Intermodal Logistics Centre at Enfield

MODIFICATION APPLICATION

ILC –E – PT3A – Modification Application No. 3
REV A

31 August 2009

SHEET 3

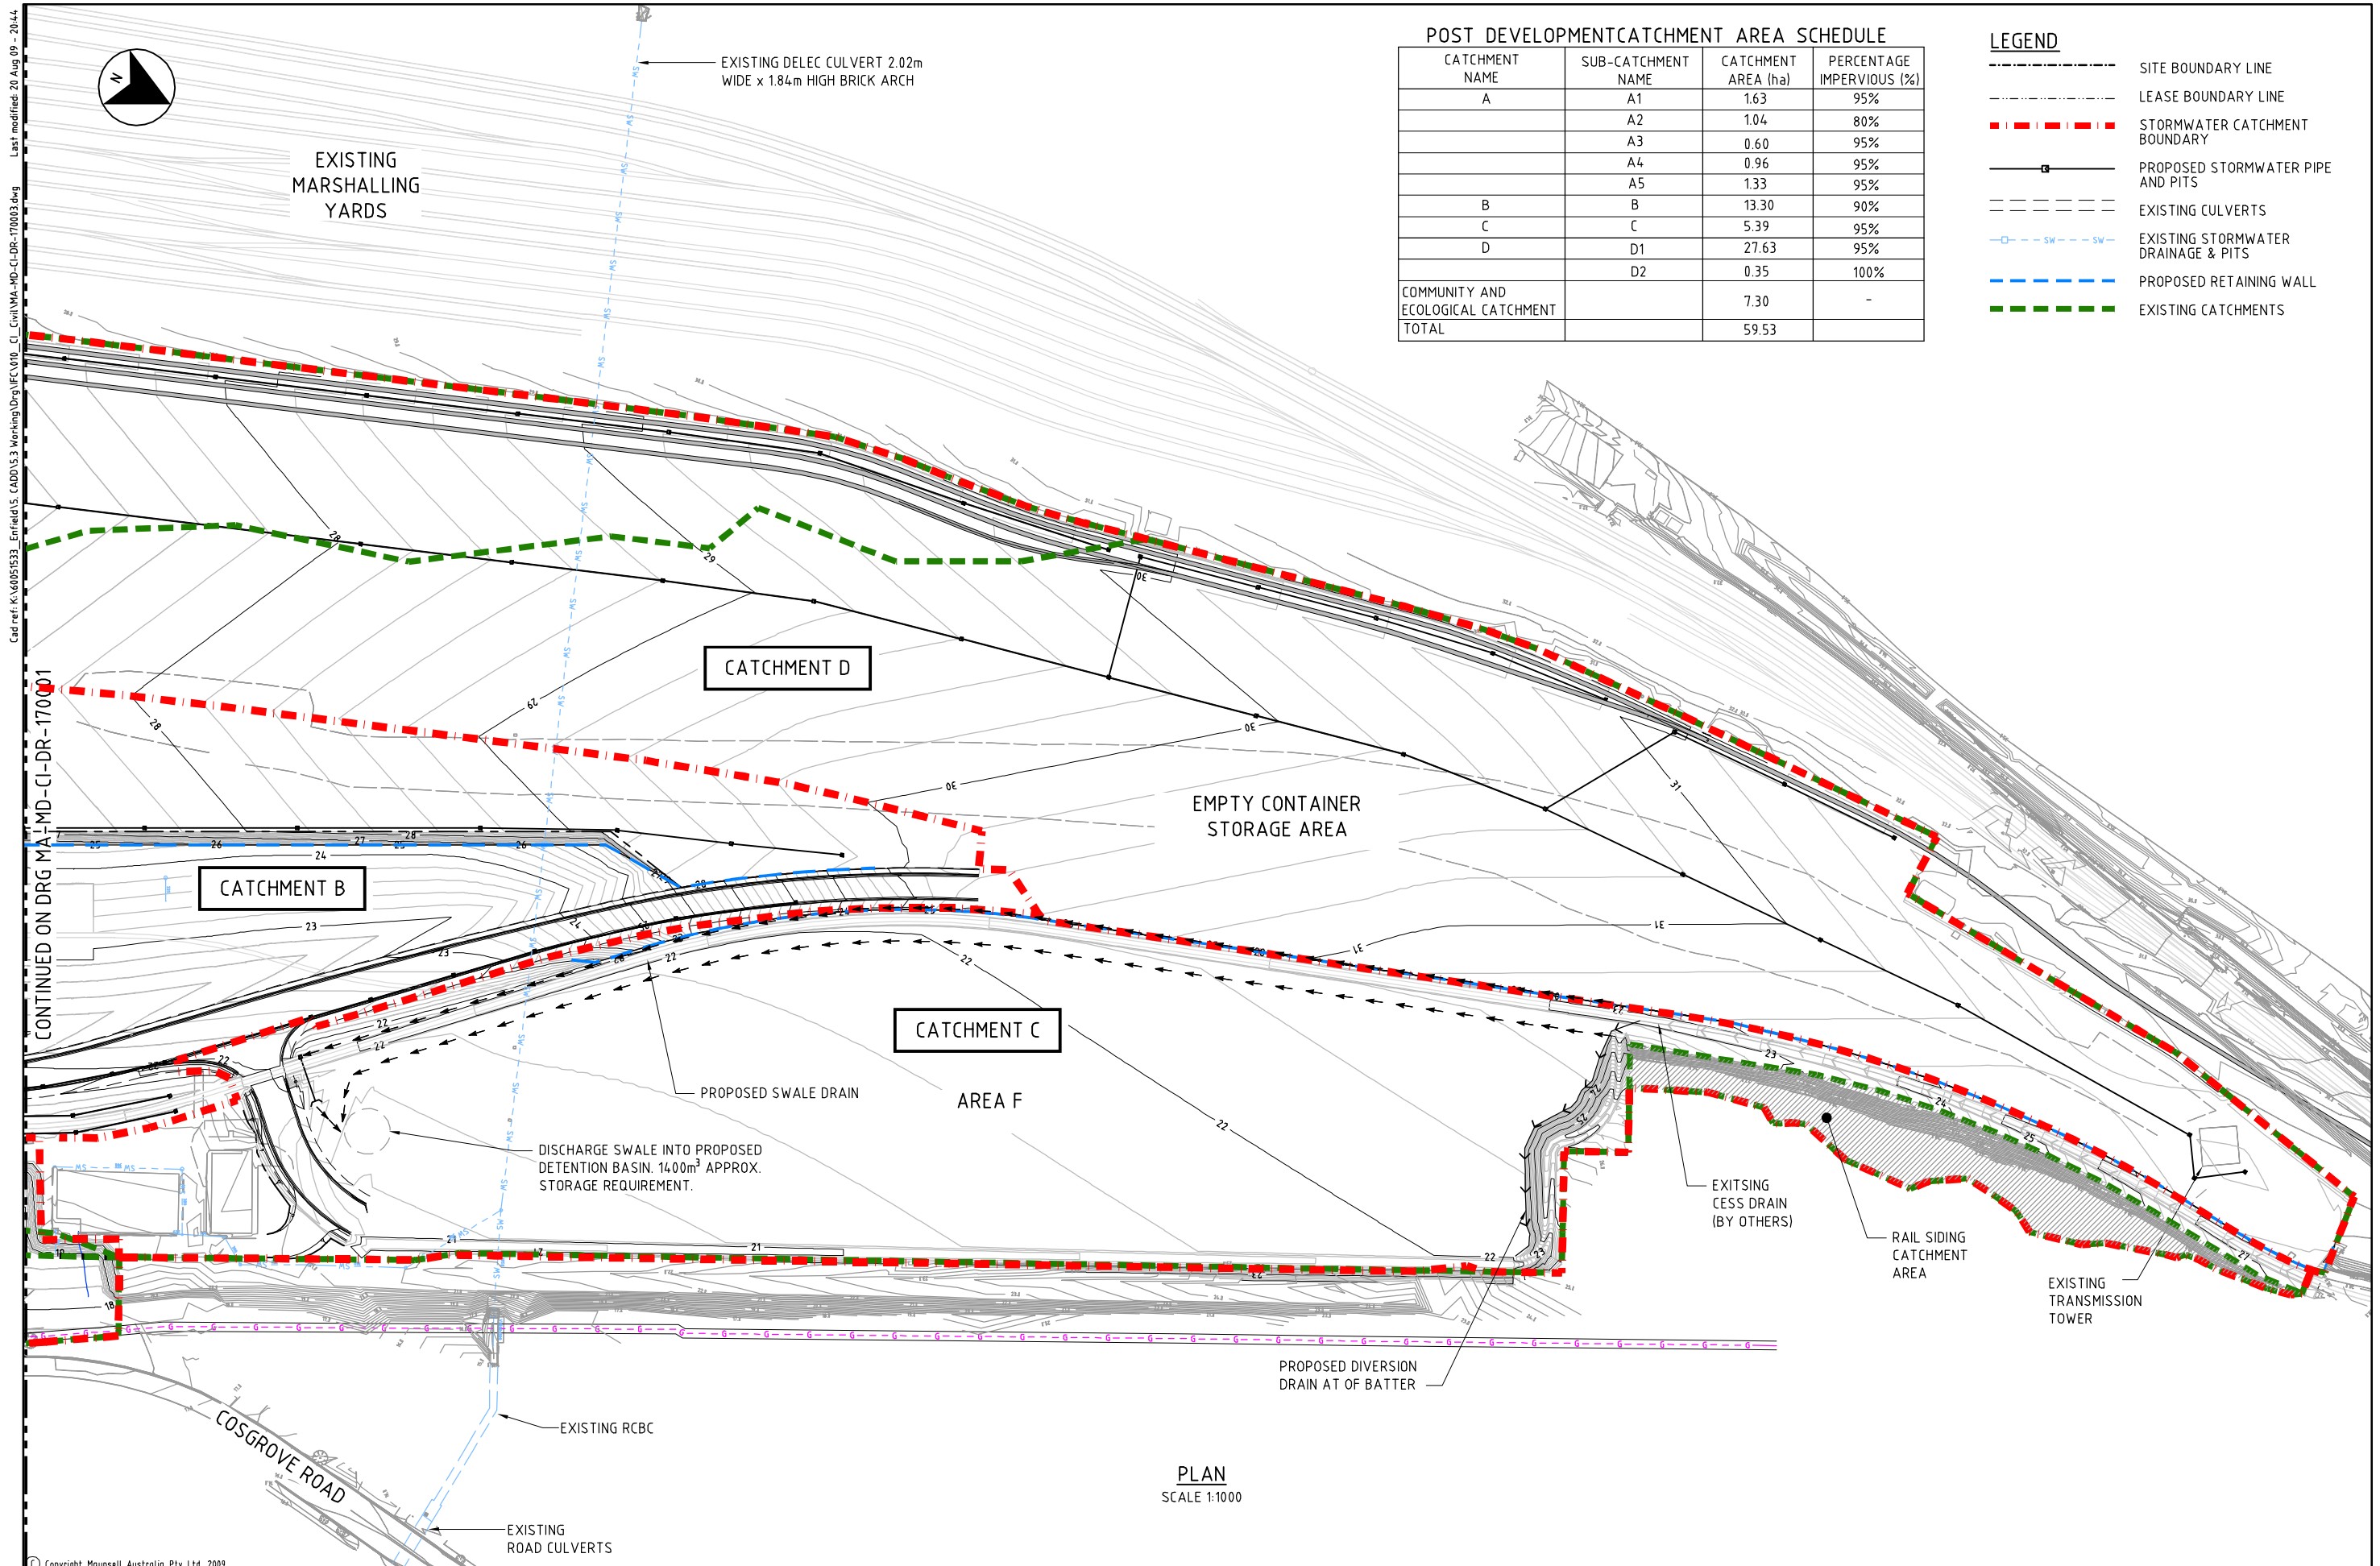
Some adjustments have been made to the detention basin catchment areas, locations and sizes (refer drawings MA-MD-CI-DR-170001 to 170003 in Appendix C) as part of the detailed design. The modified detention basin arrangement remains consistent with the approved development, comprising three above ground basin storages located downstream

- The volume of Basin B has increased from 8,000 m³ to 8,582 m³.
Basin B has been relocated to a position approximately 100 m to the north of its approved location to avoid encroachment on the existing central stormwater culvert and to improve access to the basin for maintenance. This has resulted in an increase in the area of the Light Industrial Commercial (LIC) precinct Y and a reduction in LIC Precinct Z (further described in Sections 5 and 6).
- The volume of Basin C has increased from 700 m³ to 1,400 m³.
- The volume of Basin D has reduced from 16,600 m³ to 14,760 m³.

Sydney Ports requests that Conditions 1.1 and 2.31 of the Project Approval refer to the modified basin arrangement discussed in this document.

ILC AT ENFIELD		
CONCEPT LAYOUT COSGROVE ROAD LIGHT INDUSTRIAL DEVELOPMENT AREA X		
STATUS:	DRAWING NO:	REV:
SKETCH	MA-MD-CI-SK-0102	C

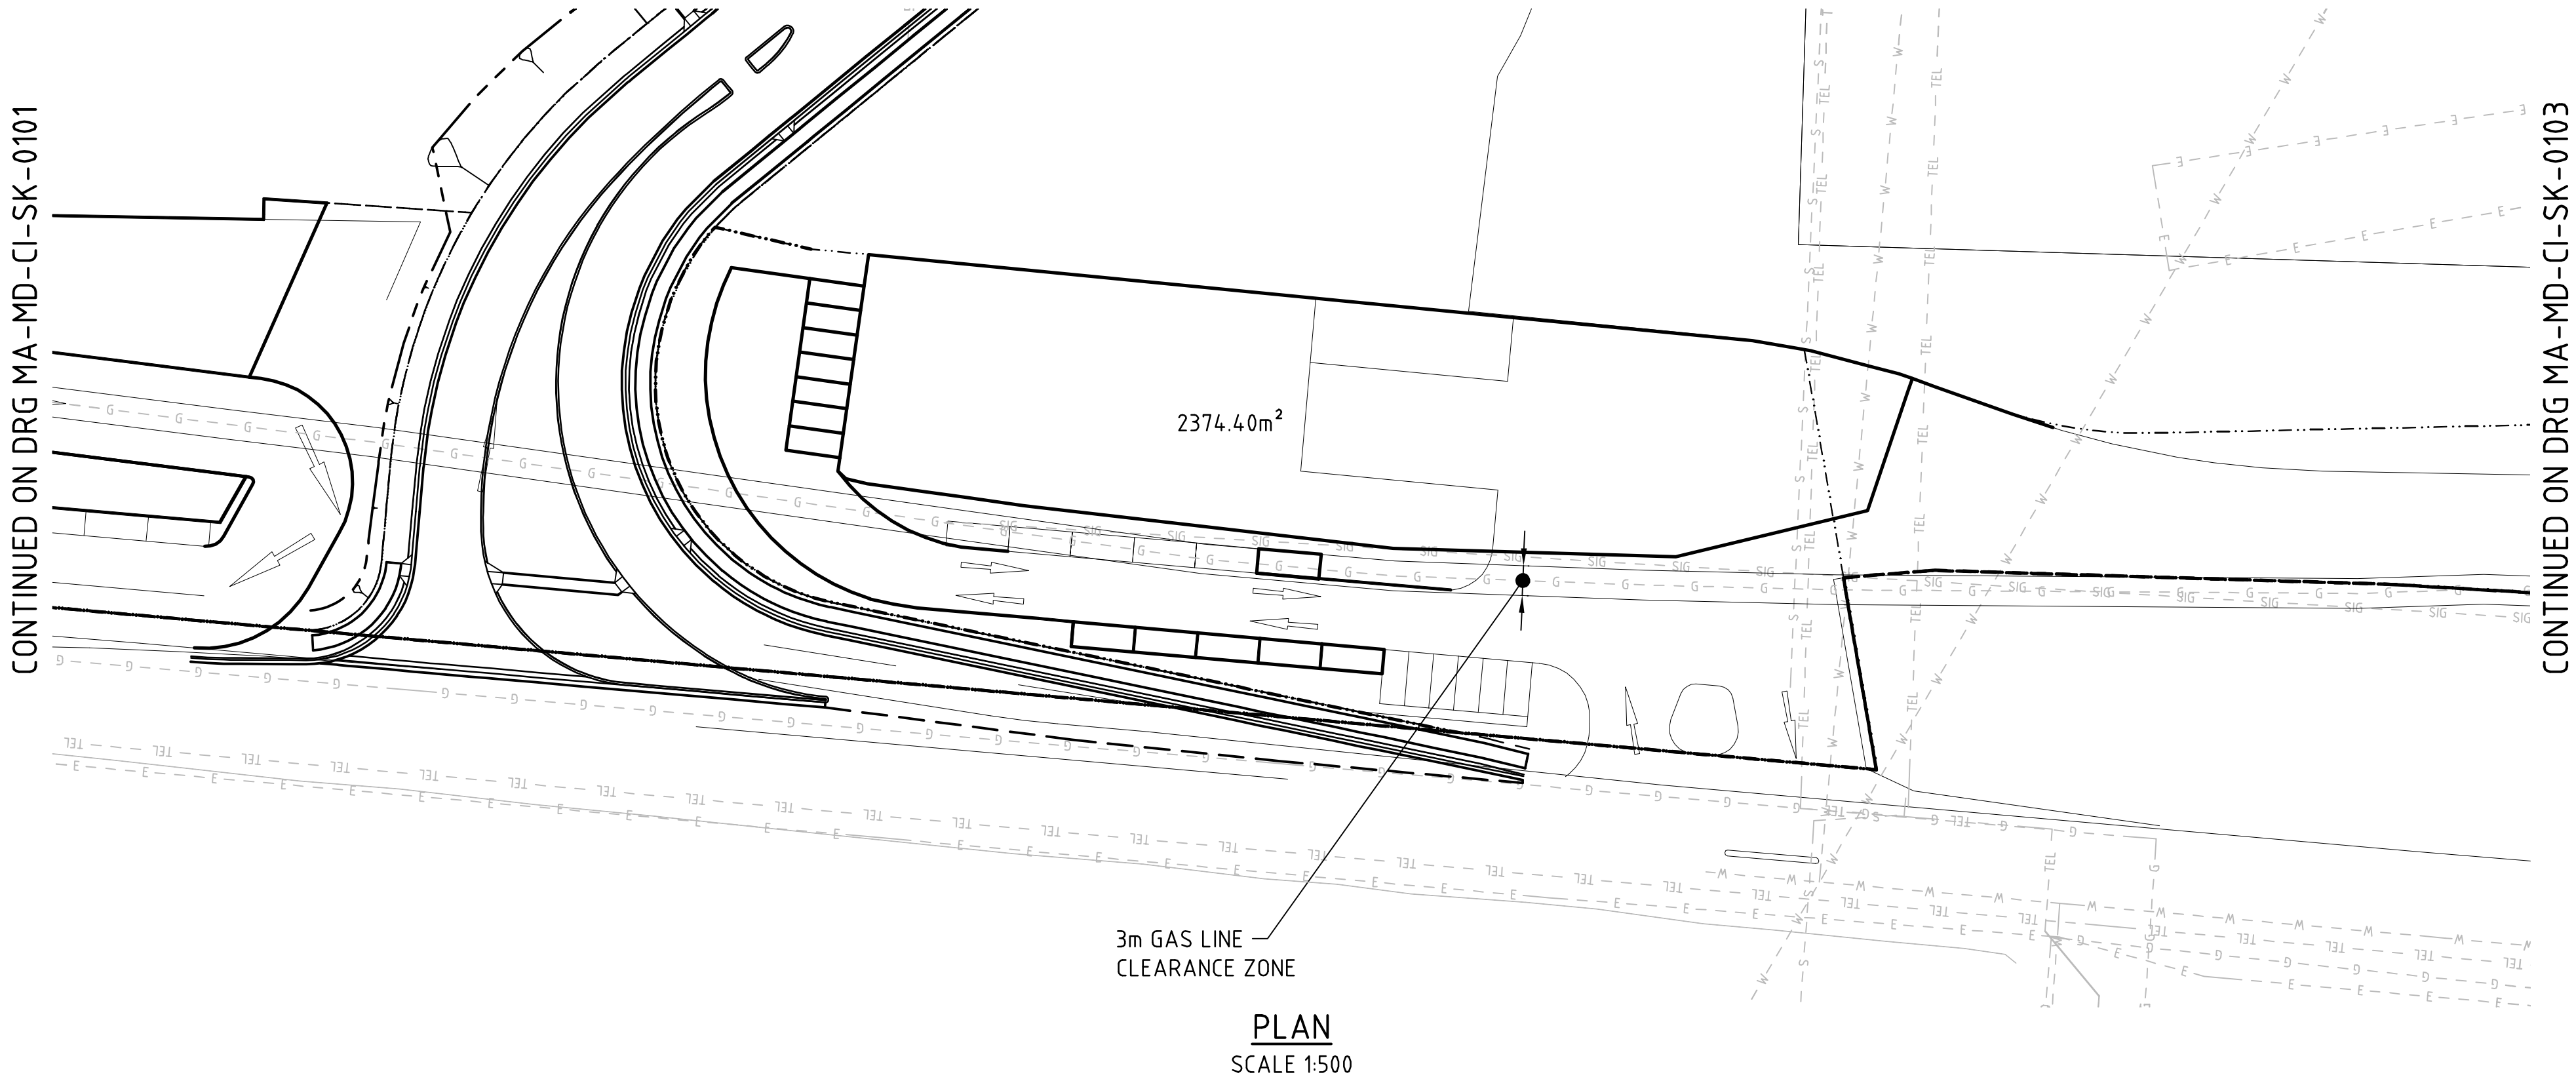
One building of similar layout is retained in Area X. The south-eastern corner of the building has been modified to improve sight lines for site safety purposes.
